RECALL Bulletin 009
Page 1 of 2
April 20, 2011 / Rev2

Defective Roll-Over Vent

Subject: Faulty operation of Roll-over vents on 2011 EPA compliant fuel tanks.

Faulty
Roll-over vent
PN 45410009

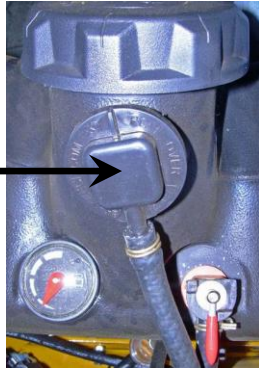
Situation: The vent membrane fails if the membrane becomes saturated with gas, causing vacuum build up in the fuel tank and shut down of the engine. Each affected unit will be required to have this recall performed.

The Fix: Replace 45410009 vent with 45410020 check valve vent. A new grommet will be included with the new vent.

Grommet and Vent Installation Instructions

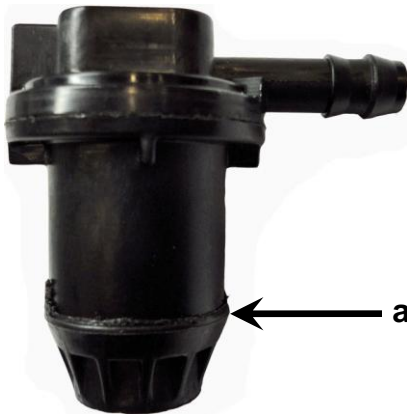
1. Remove fuel line from vent.
2. Remove faulty vent and grommet.
3. Install new grommet into fuel tank.
4. Apply lube to the new vent and push into grommet.
5. Attach fuel line.

Apply small
amounts of oil
or grease
